Your ref: EN010109

### **Application by Equinor New Energy Limited (“the Applicant”) for an Order granting Development Consent for the proposed Sheringham Shoal and Dudgeon Offshore Wind Farm Extension Projects (“Sheringham and Dudgeon Extension Projects”)**

#### **Comments on the information provided in response to the Secretary of State’s request of 22 November 2023.**

Figure 1 - Outer Dowsing Channel

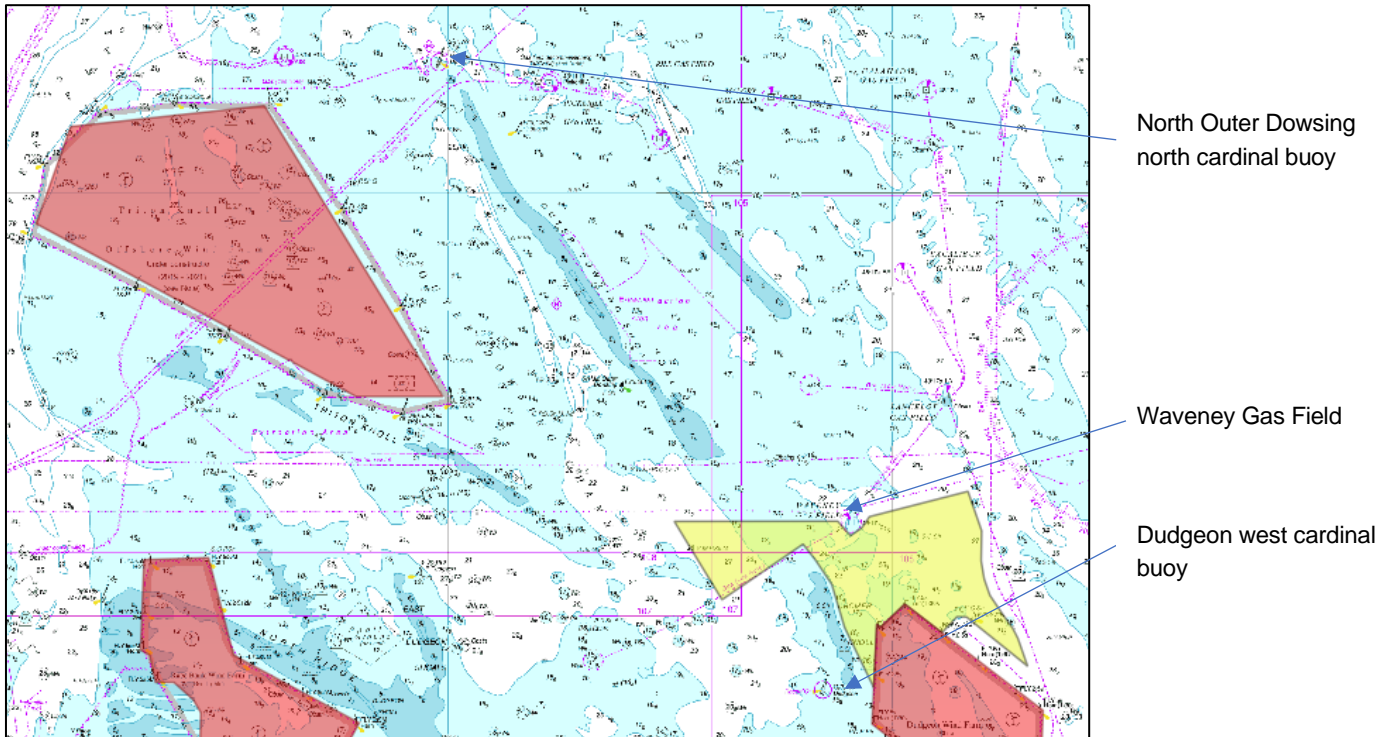
When determining the controlling depth of the area adjacent to the proposed Sheringham and Dudgeon extension projects we should look at both the vicinity of the area west of the Waveney gas field as well as the whole navigable channel from the North Outer Dowsing north cardinal buoy to the Dudgeon west cardinal buoy (Figure 1). It should be noted that whilst considering this buoy-to-buoy line as the eastern boundary of the Outer Dowsing Channel, the proposed northern site of the Dudgeon extension (DEP-North) encroaches into the Outer Dowsing Channel.

Figure 2 - Outer Dowsing Controlling Depth

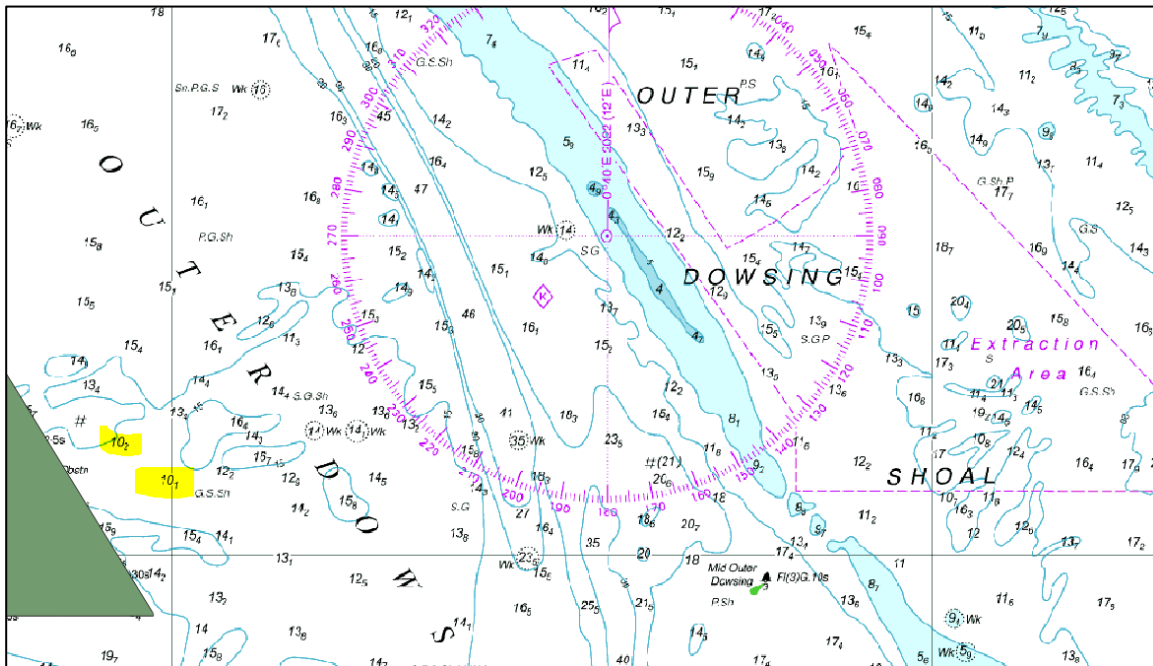
Looking at the wider picture that incorporates the Outer Dowsing Channel and utilising the terminology above, to consider the controlling depth (least depth) of the areas west of the 15m contour as 10m (we identify it as 10.1m in Figure 2) uses a very narrow interpretation of the definition, rather than the principle of the depth limiting the vessels that can transit the channel.

The identification of these depths does match the applicant’s understanding of the controlling depths within this area in that they are the shallowest depths in the channel. The applicant’s interpretation is only half of the picture and does not equate to a “critical error of fact” as implied by the applicant but rather a lack of appreciation on the controlling depth at the western extremity of the proposed DEP-North, based on the known draughts of all vessels transiting the area.

Figure 3 - Deadline 5 MCA Submission

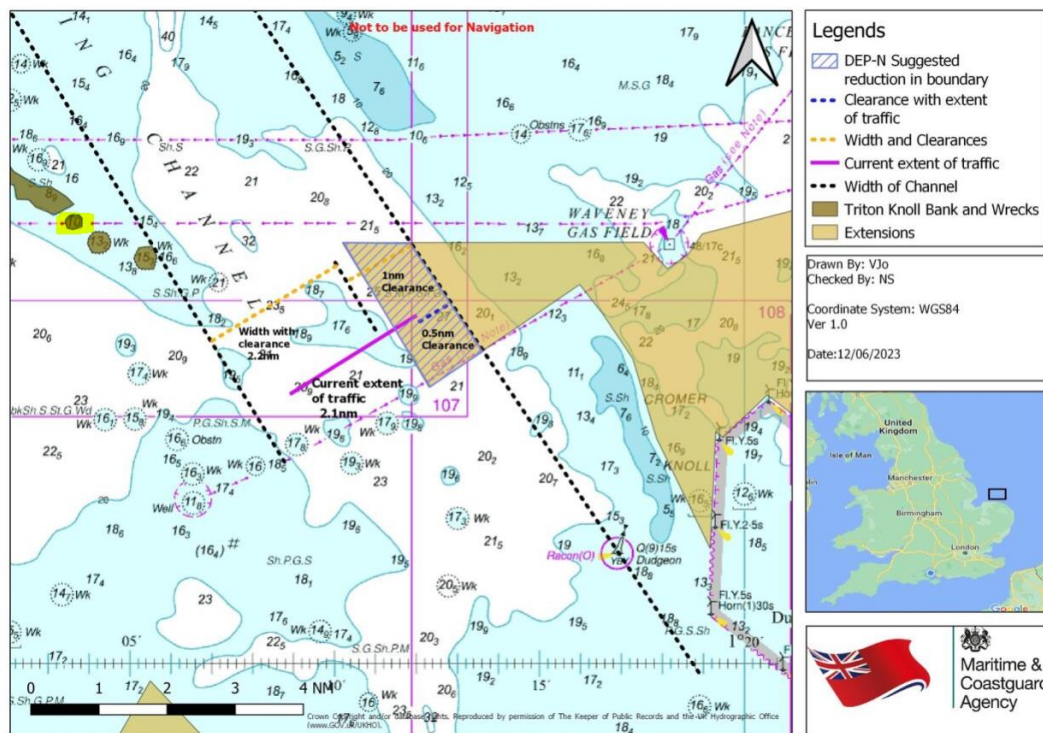
The 10.1m least depth identified above, along with the 10m controlling depth identified by the applicant directly west of the proposed western extremity of DEP-North (highlighted in Figure 3) is only acceptable from a navigation safety viewpoint if the maximum draught of vessels transiting this area is less than 10m, or 8m if considering dynamic draught and under keel clearance (UKC).

Figure 4 - 10m and 15m Contours

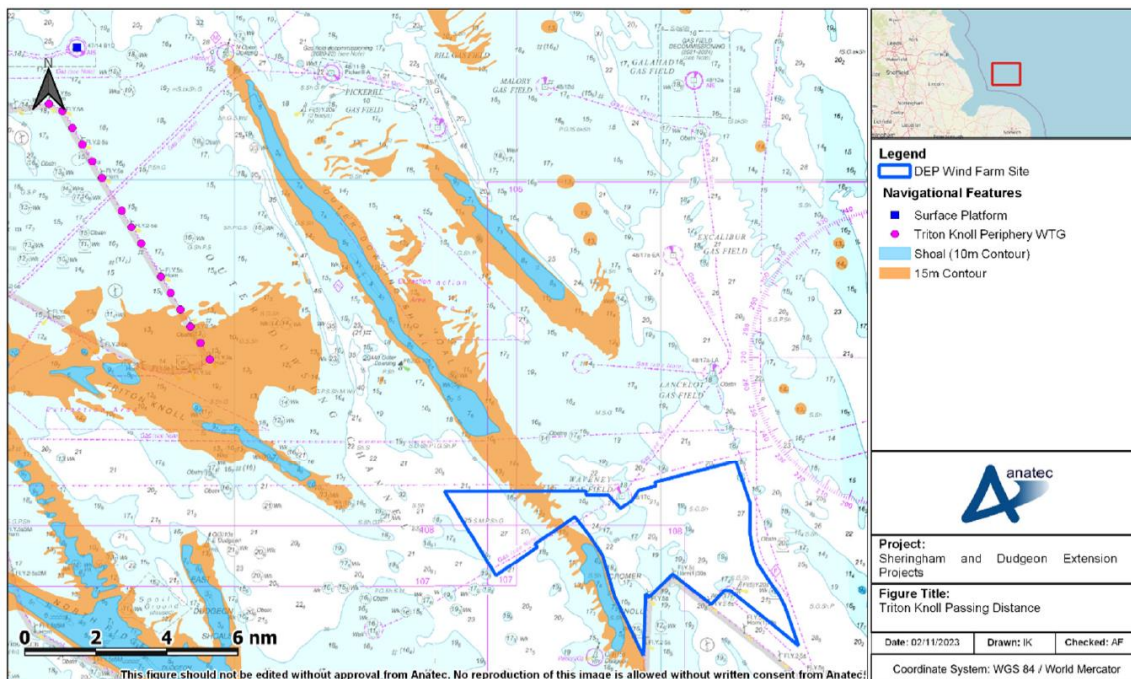
than 8m which creates excessive line population when reviewing routes. It is clear to see however, that most vessels maintain the 15m contour as the basis for their passage (Figure 4 and 5) and therefore it can be determined that navigators are maintaining routes and utilising waypoints based on this depth analysis in line with their minimum UKC requirements and an agreed cross track corridor.

On review of the available information provided by the applicant, the controlling depth they use within the limits of the Outer Dowsing Channel is 10m, on the assumption the channel is taken from the navigational marks on the east to the extremities of the Triton Knoll windfarm (Figure 4). This is using a very narrow and specific interpretation of the definition as stated within the Mariner's Handbook rather than the wider principle as applied in vessel navigation decision making and is based on an assessment where the traffic data is not considered. It is clear from Figure 6 that vessels transiting the area do not use 10m as the controlling depth but are maintaining the 15m contour and therefore at the critical juncture west of DEP-North, the 15.3m wreck is the natural controlling depth.

Figure 5 - 28 Days of Vessel Tracks Colour Coded

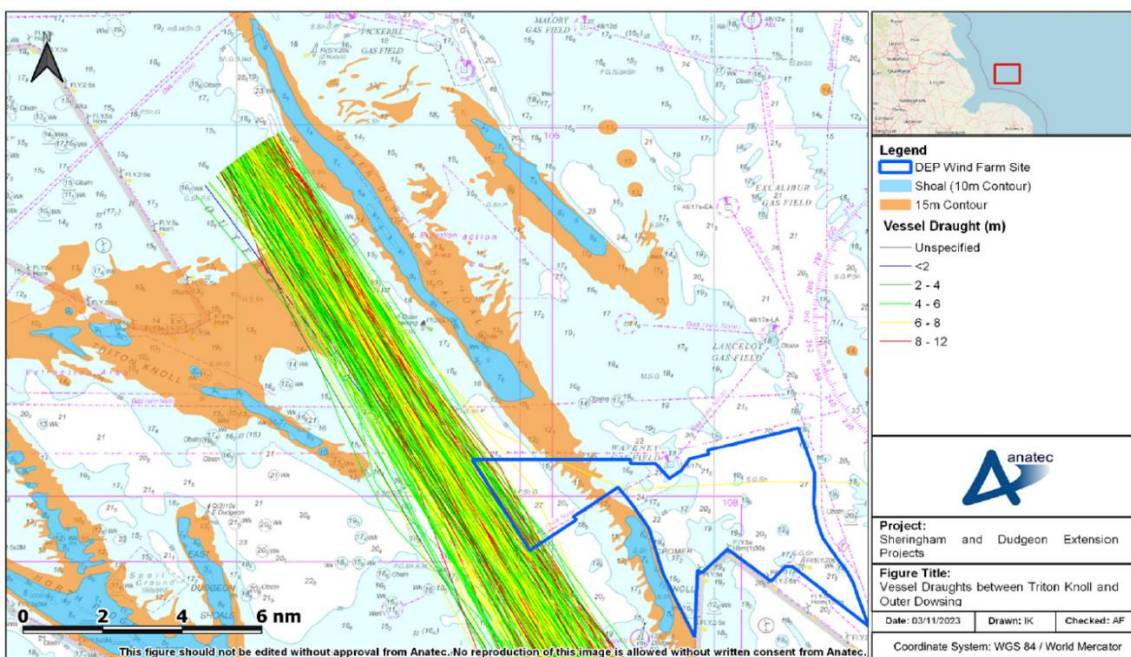
We can see that utilising a control depth of 10m or 10.1m for the entire area from the North Outer Dowsing north cardinal buoy to the Dudgeon west cardinal buoy is inappropriate and does not relate to real life vessel transits. We can see in Figure 6 that an assumed channel edge leading from the 15.3m wreck (identified within the black square) to the 15m contour on the western side of the Mid Outer Dowsing starboard hand lateral mark is the natural route assessed by vessel navigators and utilised accordingly. It can be seen that the deeper draught vessels (red lines in Figure 5) maintain greater clearance using the centre of the channel in keeping with our channel width.

Figure 6 - 15.3m controlling depth and natural channel edge

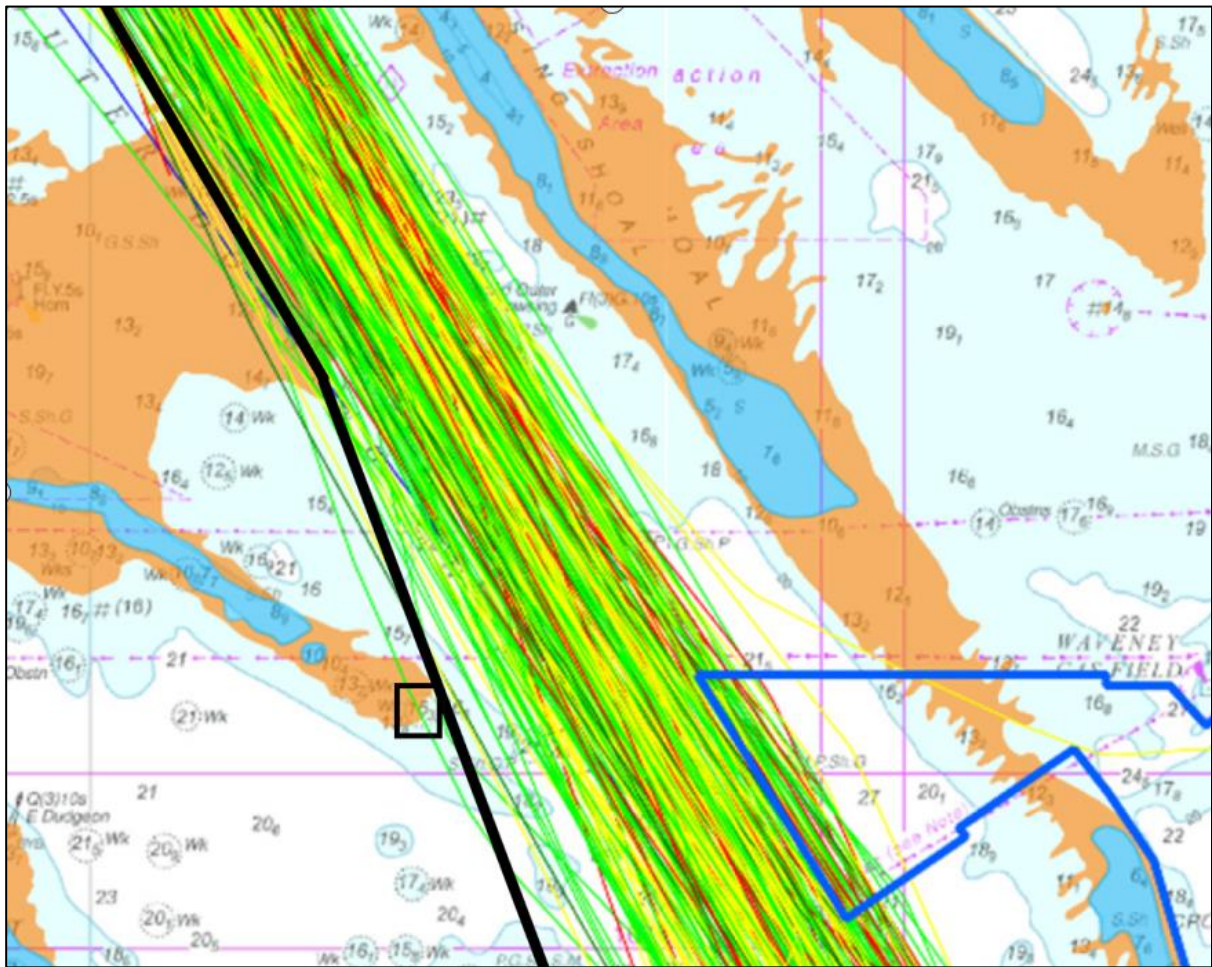
The AIS data provided by the applicant (Figure 6) indicates that most vessels maintain a distance of approximately 0.8nm from the Mid Outer Dowsing lateral buoy and Dudgeon west cardinal buoy as well as a similar distance to the 15.3m wreck and shallow patch to the west. The applicant has assessed post installation routing within their NRA and has stated that it is not expected that the proposed DEP-North site will affect vessel routing, therefore potentially acknowledging that mariners will continue to utilise the 15.3m wreck and 15m contour as the controlling depth. What is not assessed or acknowledged fully within this section of the NRA is the potential increased collision risk caused by the reduction of sea room if transiting vessels do not reassess routes and waypoints to base their controlling depth on 10m, which has been used as the basis for the applicant's ALARP assessment. On analysis of the current traffic movements, traffic routes, and utilising the applicant's NRA in relation to post installation expectations, it is

The controlling depth therefore can be determined as 15.3m at area adjacent to the most westerly point of the proposed DEP-North site.

Figure 7 Recommended reduction in RLB or 'structures exclusion area'

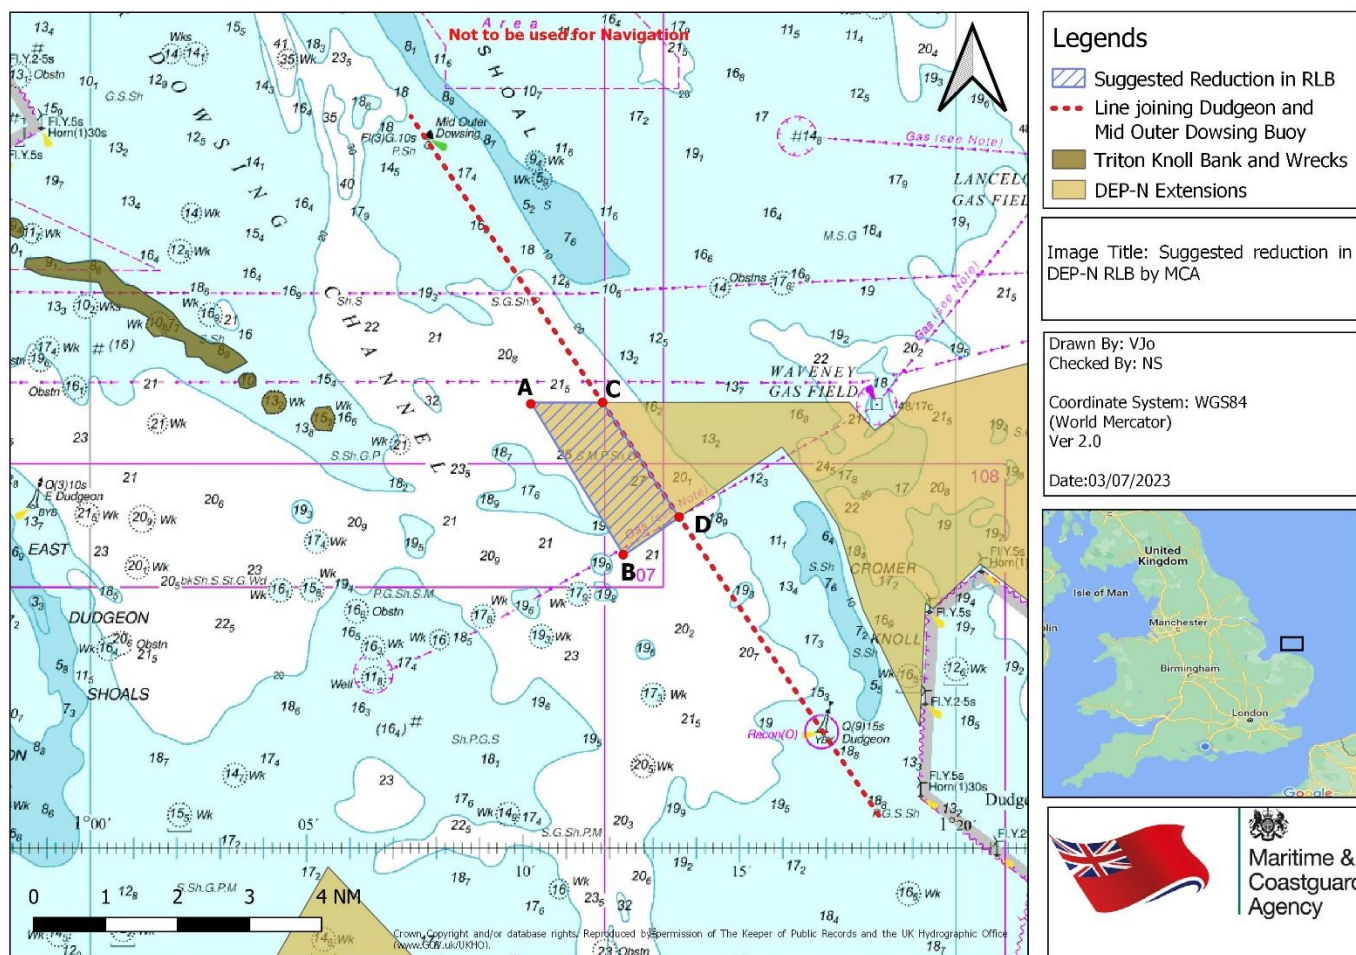
the opinion of the MCA that there is a potential for increased collision risk due to the reduction of available sea room which we believe has not been adequately assessed within the NRA and no clear mitigation identified. Given the likely squeeze of traffic when safe passing distances are applied, MCA's assessment was that vessels will be constricted into a route 1.3NM wide which, given the high collision risk already present in the area, we believe to be insufficient. The narrowing of the channel will increase the frequency of encountering head on situations and merging traffic and will limit mariners' options for taking early and substantial avoiding action if a collision scenario is identified. This in turn increases the risks of collision with the turbines and grounding on nearby shallow banks.

Therefore, the appropriate mitigation as per our Deadline 7 and 8 submissions on 6 July 2023 and 17 July 2023 respectively, is either a reduction in the Red Line Boundary to a line joining the Mid Outer Dowsing lateral buoy and Dudgeon west cardinal buoy, or a commitment to not construct any structures in the hatched area in Figure 7 which would provide a 3.2NM width of sea room measured from the 15.3m wreck and the buoy-to-buoy line. In this regard, and in reference to the applicant's assertion that our position is contrary to Trinity House's position, it is noted that Trinity House confirmed at Deadline 5 that they "would defer to the MCA, as the primary navigational safety body, when defining shipping routes/lanes and assessing the appropriate widths of corridors as per MGN654".
